Replacement Requirement for 22 kW High-Voltage Charger - OBC (240/24)

Model Year: **As of 2020 up to 2024**

Model Line: **Taycan (Y1A/Y1B/Y1C)**

Equipment: 22 kW high-voltage charger (**M-no. KB4**)

Convert bracket holder at bottom (2WD)

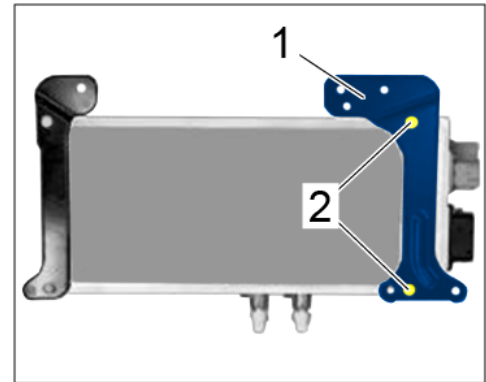
Work Procedure: 1 Convert bracket holder at the bottom of the vehicle from the previous left position ⇒ *Convert bracket holder at bottom (2WD) -1-* to the new, right position ⇒ *Convert bracket holder at bottom (2WD) -2-* ⇒ *Convert bracket holder at bottom (2WD) -Arrow-*.

- 1 – Previous holder position for 22-kW high-voltage charger
- 2 – New holder position for 11-kW high-voltage charger
- 3 – Fastening screws for lower bracket holder (shown at new holder position)
- 4 – Fastening nut for lower bracket holder (shown at new holder position)

- 1.1 Remove lower bracket holder at position ⇒ *Convert bracket holder at bottom (2WD) -1-*, by unscrewing screws ⇒ *Convert bracket holder at bottom (2WD) -3-* and nuts ⇒ *Convert bracket holder at bottom (2WD) -4-*.
- 1.2 Move lower bracket holder from the left position ⇒ *Convert bracket holder at bottom (2WD) -1-* to the right position ⇒ *Convert bracket holder at bottom (2WD) -2-*.
- 1.3 Install and tighten **new** screws ⇒ *Convert bracket holder at bottom (2WD) -3-* and **new** nuts ⇒ *Convert bracket holder at bottom (2WD) -4-* on newly positioned lower bracket holder ⇒ *Convert bracket holder at bottom (2WD) -2-*.

Tightening torque 8 Nm (5.9 ftlb.)
